OUR REF: J000975: MIS: KLG

RE: RESPONSE TO INFORMATION REQUEST - APPLICATION FOR A DEVELOPMENT PERMIT FOR MATERIAL CHANGE OF USE (AIR SERVICES) AT 2224 TULLY-MISSION BEACH ROAD, MISSION BEACH

I refer to the above-mentioned application seeking a Development Permit for a Material Change of Use for Air Services (Aviation Facility) at 2224 Tully-Mission Beach Road on land formally described as Lot 3 on RP732964 (the subject site), as submitted by Gilvear Planning Pty Ltd (Gilvear Planning) on behalf of Mission Helicopters Pty Ltd (the applicant).

An Information Request was issued by the Cassowary Coast Regional Council (Council) on 6 March 2020. Pursuant to Part 3, Section 13.2(a) of the Development Assessment Rules, the following response is provided on behalf of the applicant.

plan - air services facilities

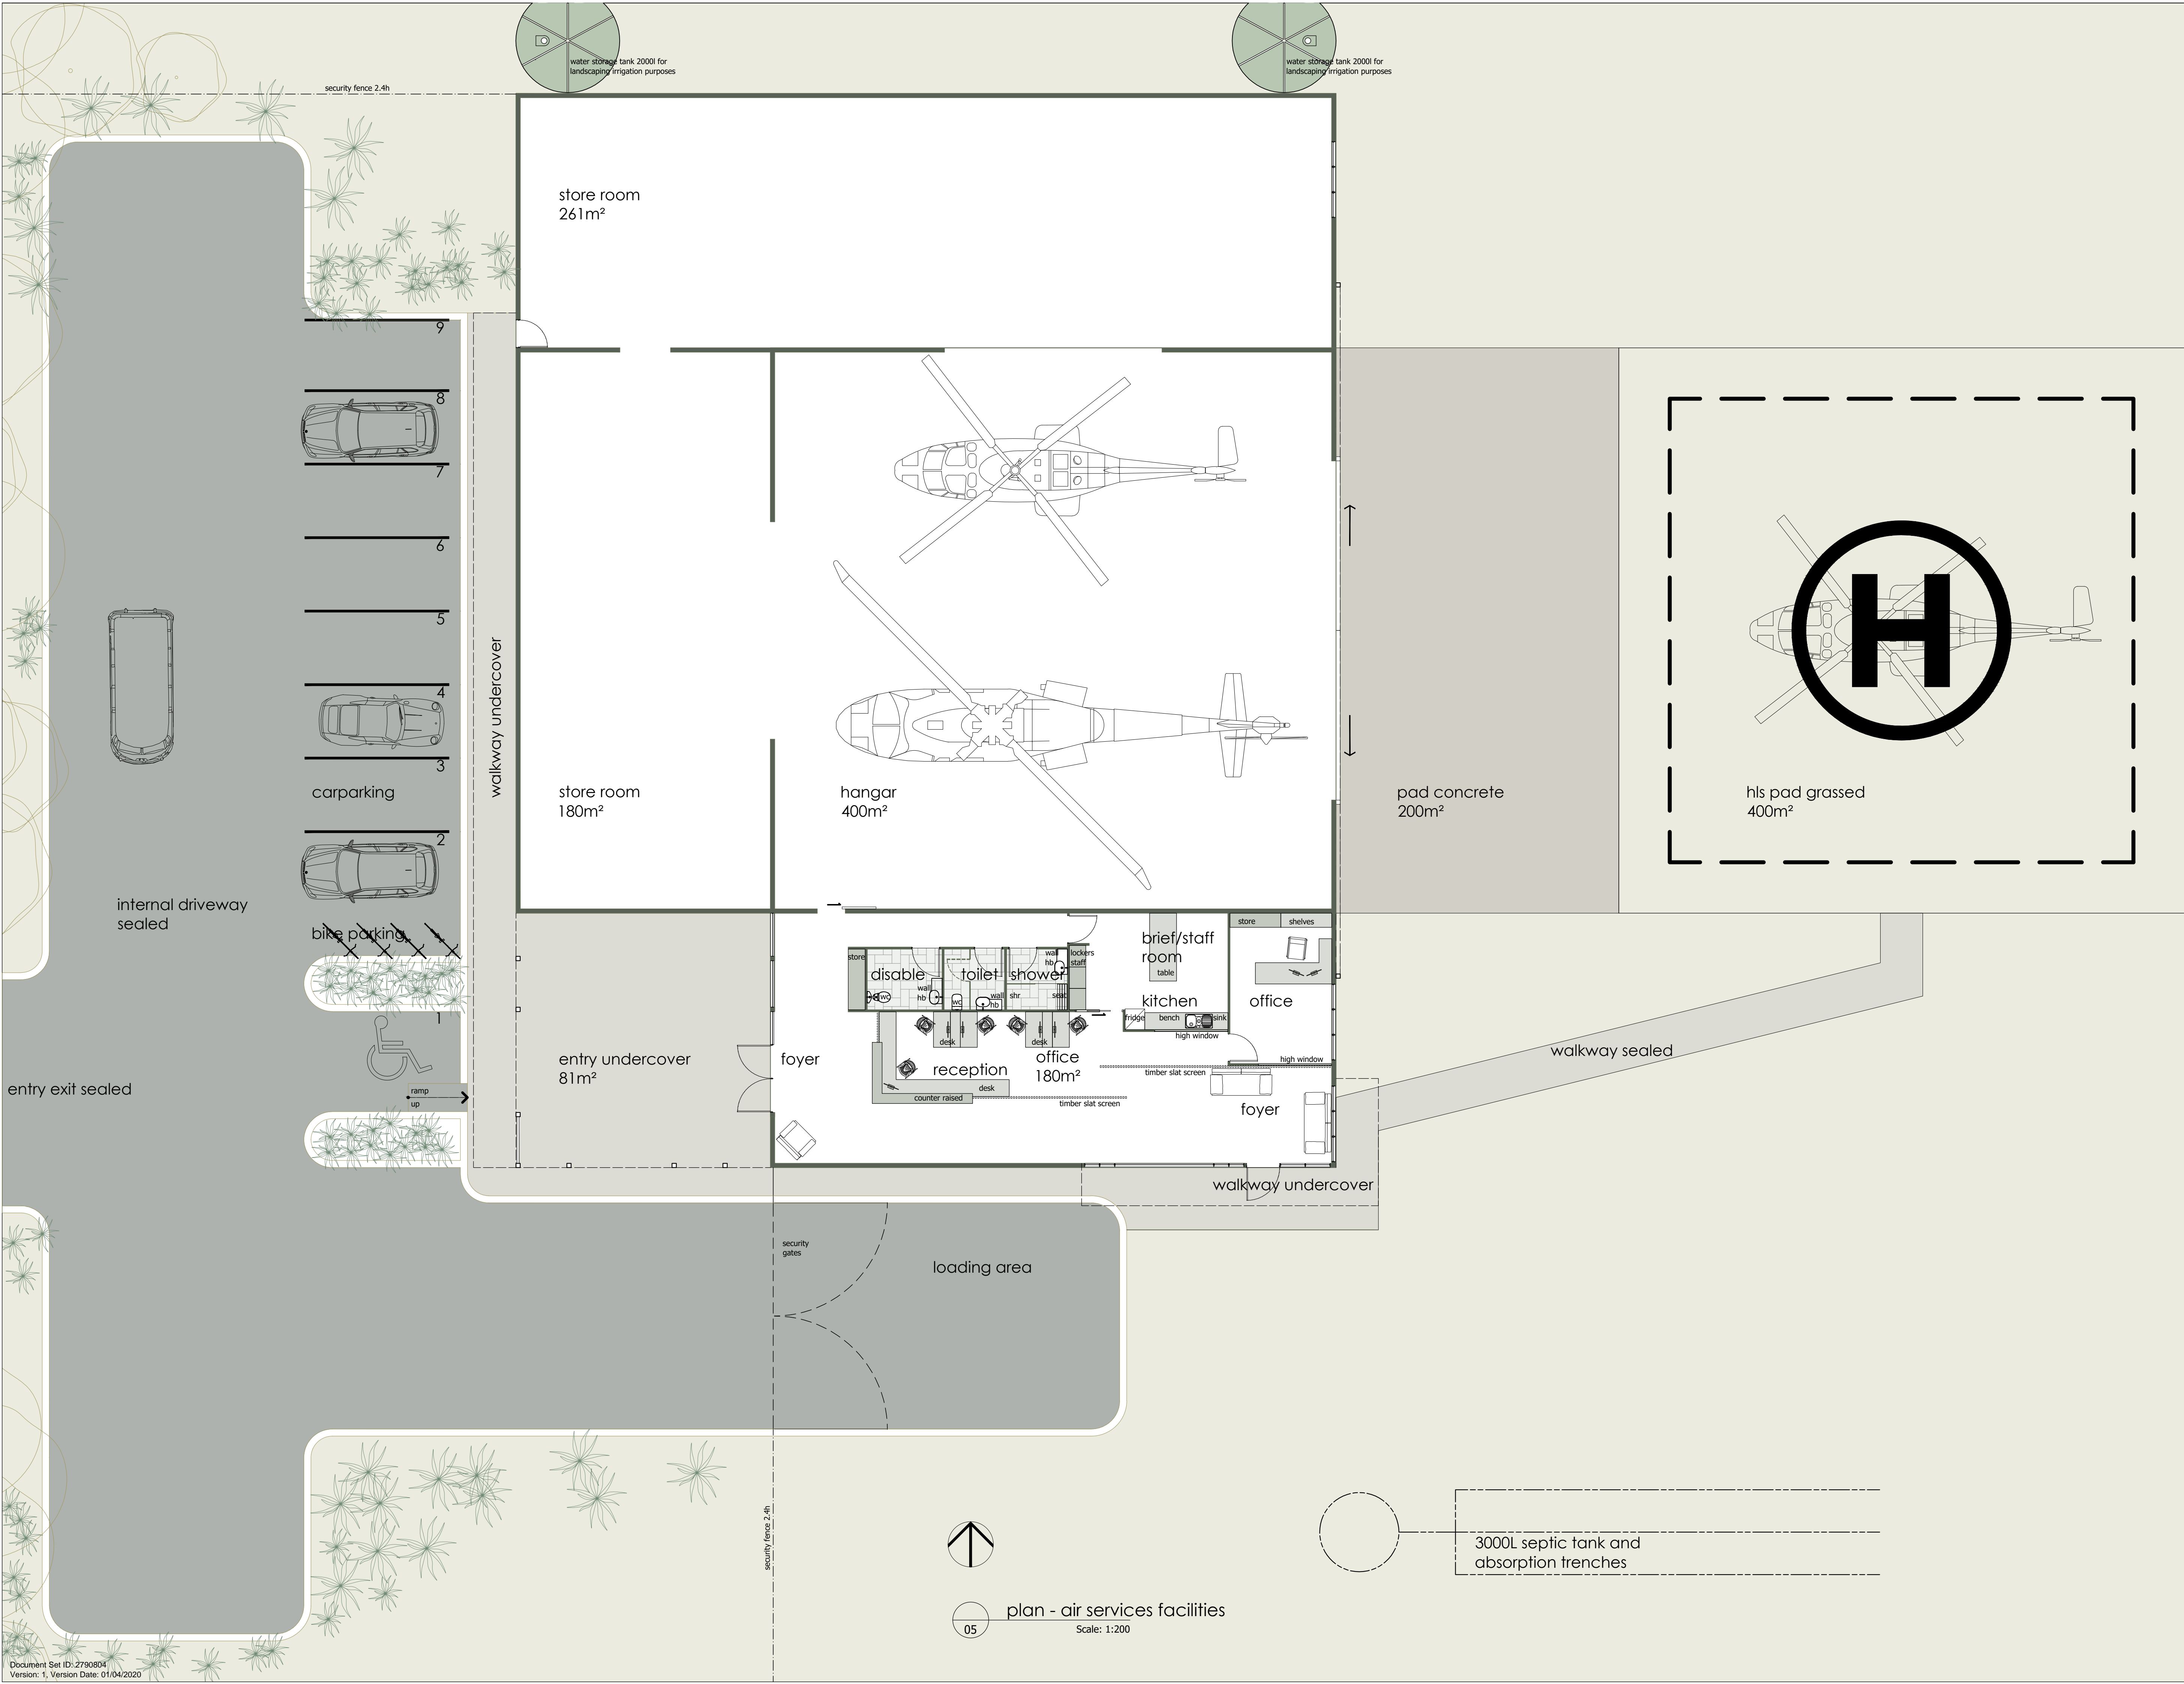
Information Request Items 1 and 3 – Clarification on Refuelling Process and Fuel Storage

Information Request Item 2 – Septic System

In response to Council's Information Request Notice, the applicant has reviewed and subsequently amended the proposed development by removing the proposed fuel storage area. Demand for fuel at the subject site is minimal and can be accommodated via the use of smaller storage containers which will be stored inside the hangar area. The use of smaller storage containers will reduce the need to store bulk fuel at the subject site. This allows for greater control measures to be implemented to mitigate / manage risks associated with potential release.

Updated Plans showing the location of the proposed septic system and soakage trench are included in *Attachment 1 - Updated Proposal Plans*.

3000L septic tank and
absorption trenches
